24105-L10-BT

EQUITABLE BUILDING, MANCHESTER – FURTHER PLANNING QUERIES

Following the issue of dBx Acoustics report ref 24105-R02B-BT, and letters L06 and L08, it is understood that Manchester City Council (MCC) has requested further information before they will determine planning conditions associated with planning applications 141994/FO/2025 and 141995/FO/2025.

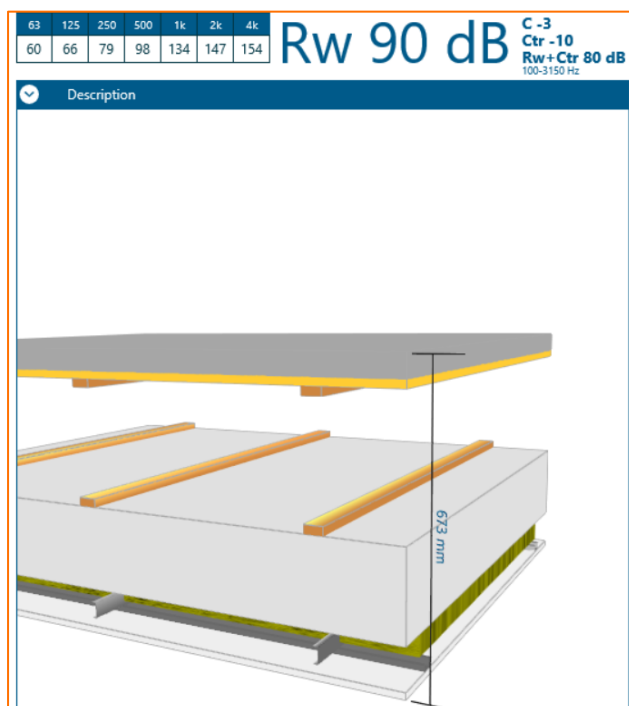
Point 7 Noise Transfer - The response confirms that testing of the separating floor performance for the newly created 4th floor will be tested at validation stage. However, the report should be including recommendations for the performance / build requirements before it is built so it can be incorporated into the design stage to ensure the apartments will be suitably insulated against noise transfer from the commercial units below.

The commercial units are on ground and first. There are no commercial units on 2nd, 3rd or 4th floors.

Noise from commercial units was considered in our letter ref 24105-L06-BT Equitable Building Planning Tracker, dated 17/04/2025. Even the base existing concrete floor alone was shown to control noise levels of $75\text{dBL}_{\text{Aeq},T}$ to inaudibility in the flats above.

The ground and first are being designed by a different design team, for a different end user, and hence we have no direct control over the design of this element. However, it is understood that a plasterboard ceiling is also to be provided to the first floor soffit.

This will increase the sound insulation performance by at least 10dB. On this basis, noise levels of up to $85\text{dBL}_{\text{Aeq},T}$ (the second action level in the Noise at Work Regulations) would be controlled to inaudibility in the apartments above. Noise levels in a jewellery store would be expected to be significantly (30dB or more) lower than this.
